1990 - 1992 Corvette ZR-1: Service Bulletin: No Start Condition (Replace Starter)

Subject: NO START CONDITION (STARTER CORROSION-REPLACE STARTER)

Model and Year: 1990-1992 Corvette, Engine Code J (LT5)

Bulletin Number: 92-307-6 - (09/21/1992)

Figure 1

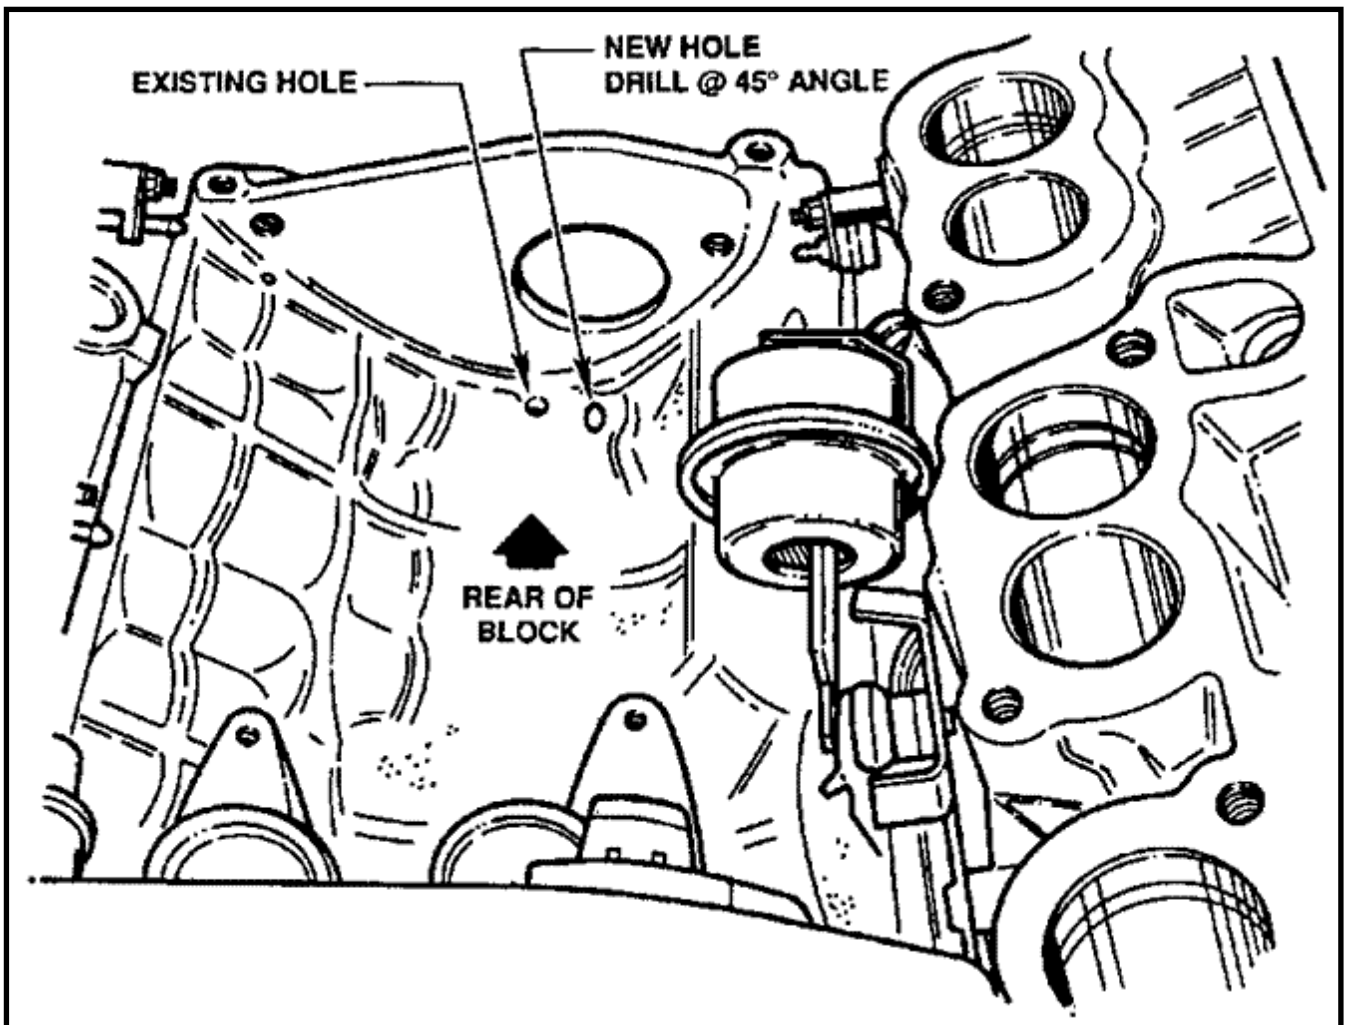
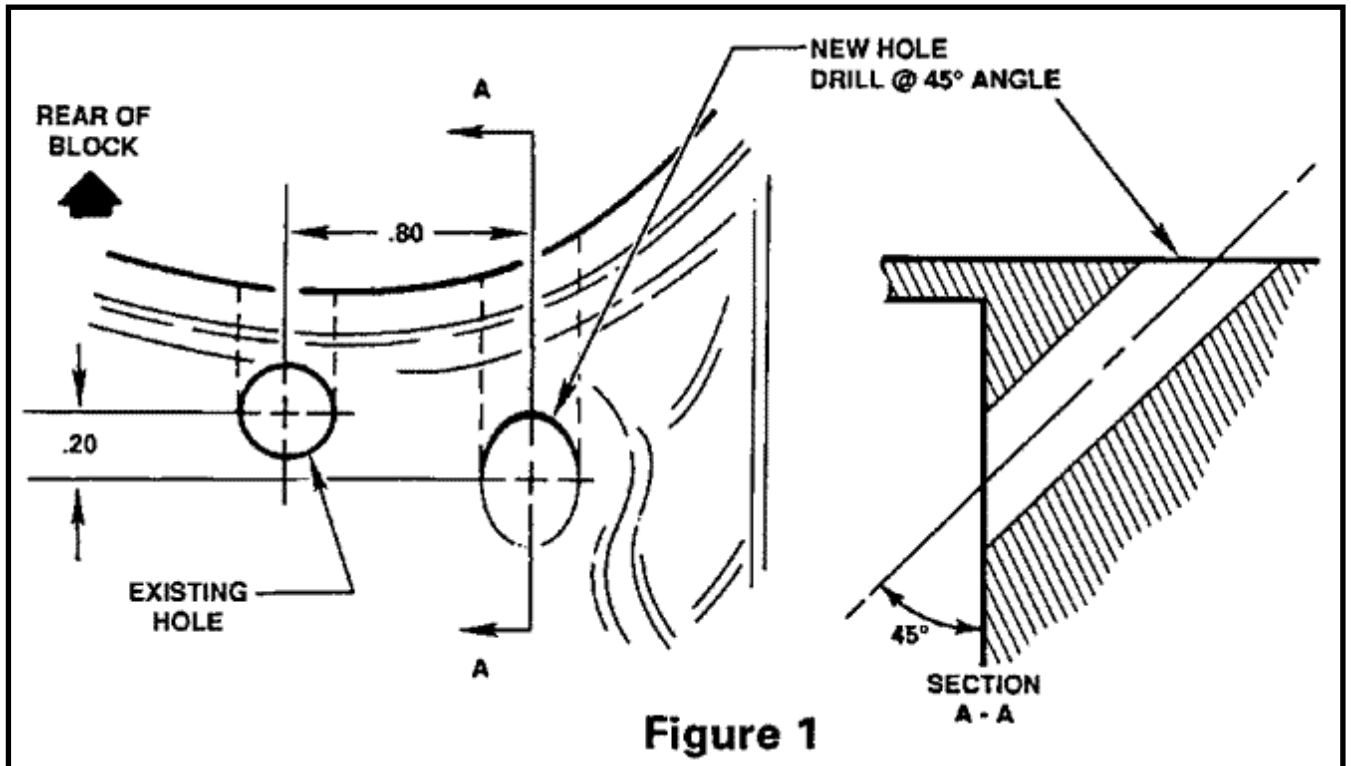
Some ZR1 Corvettes may exhibit a no start condition due to starter corrosion. This condition is most likely to occur after the engine has been washed.

The starter on an LT5 engine is mounted in the engine "vee." A drain hole and drain tube are located at the rear of the engine valley. While washing the engine, debris may settle in the engine "vee" and block the drain system.

- 1 . Remove the old starter.
2. Clean any blockage in existing drain system.
3. Drill a 3/8" diameter hole through the engine "vee" to the back of the engine, allowing drainage (see Figure 1).
